**NUCLEAR REACTOR LABORATORY**  
AN INTERDEPARTMENTAL CENTER OF  
MASSACHUSETTS INSTITUTE OF TECHNOLOGY

Subject: Revision to MITR Technical Specifications #7.1 / Reply to Close Out  
Open Item #50-20/2001-202-01

## 7. ADMINISTRATIVE CONTROLS

Fig. 7.1-1 Management Organization

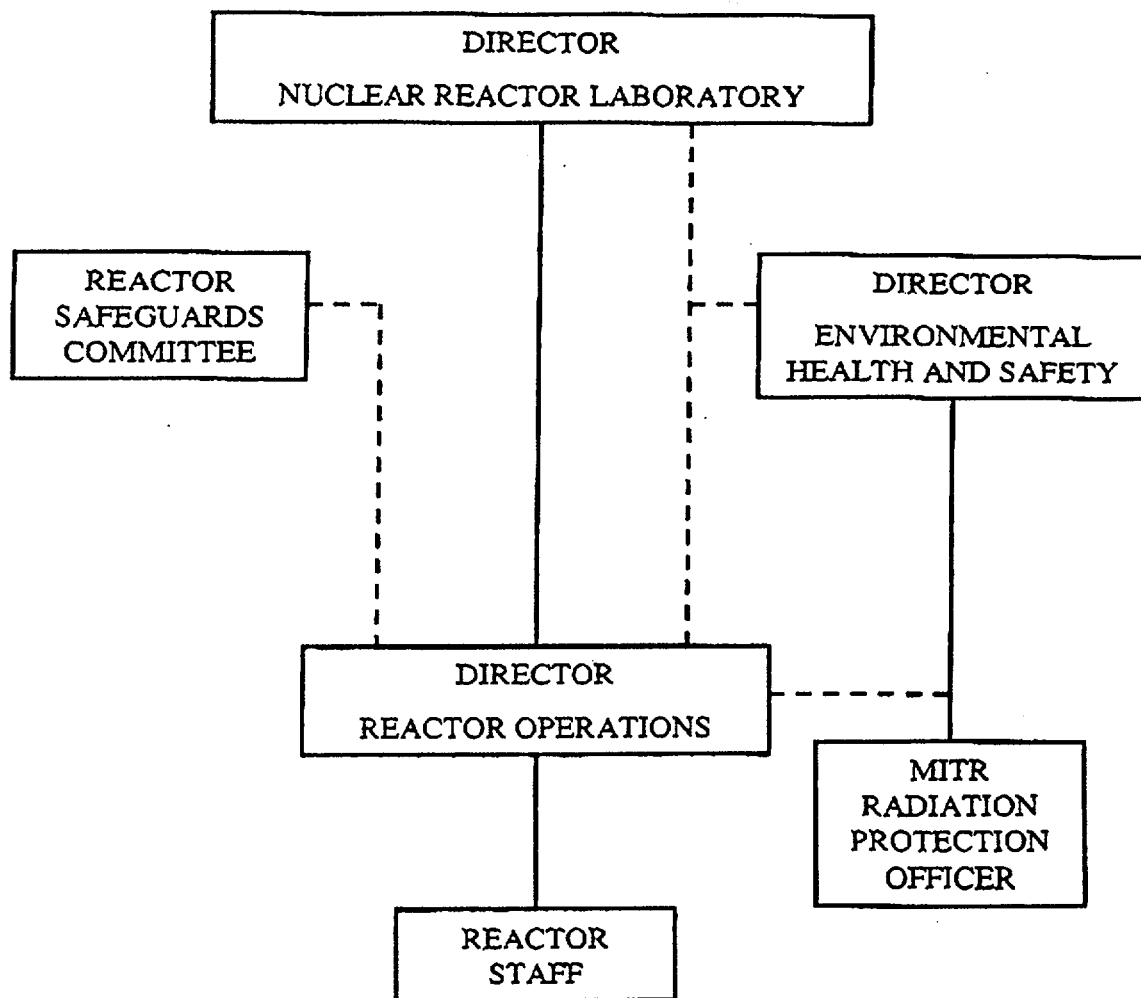
Enclosed is a revision to Massachusetts Institute of Technology Research Reactor Technical Specification #7.1 which reflects changes in the administrative structure at MIT. Please note that submission of this item should close out open item #50-20/2001-202-01 from NRC Inspection Report #50-20/2001-202 dated August 20, 2001.

7.1.2 In all matters pertaining to safe operation of the MIT Reactor (MITR) and to these Technical Specifications, the Director of Reactor Operations shall report to and be directly responsible to the Director of the Nuclear Reactor Laboratory. The management organization is shown in Figure 7.1-1.

7.1.4 The MITR Radiation Protection Officer shall report to, and be directly responsible to, the Director of MIT Environmental Health and Safety.
